BULLETIN NO. 261

MACHINE: **Model C Machines**
M3 Model B

SUBJECT: **COBRA BRAKES**

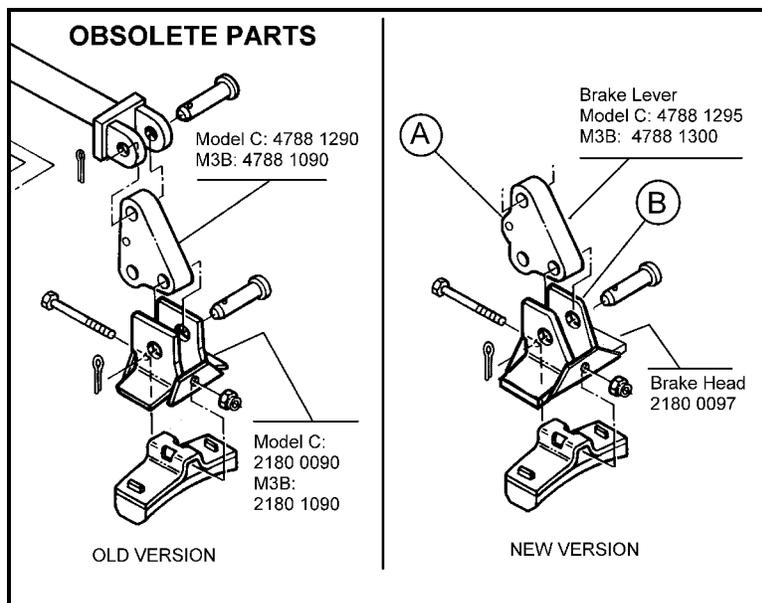
See drawing below for differences between the old version and new version of these parts. If your brake head or brake lever resemble those in the "old version" you need to order both the new style brake head and the new style brake lever ("new version") when ordering repair parts for the first time. Changes in the design of both the lever and the brake head does not allow interchangeability of "old" and "new" parts. (i.e., old brake levers will not work with new brake heads.)

The primary changes in design were at points "A" and "B" in the new version shown. Both became more rounded to provide a better fit.
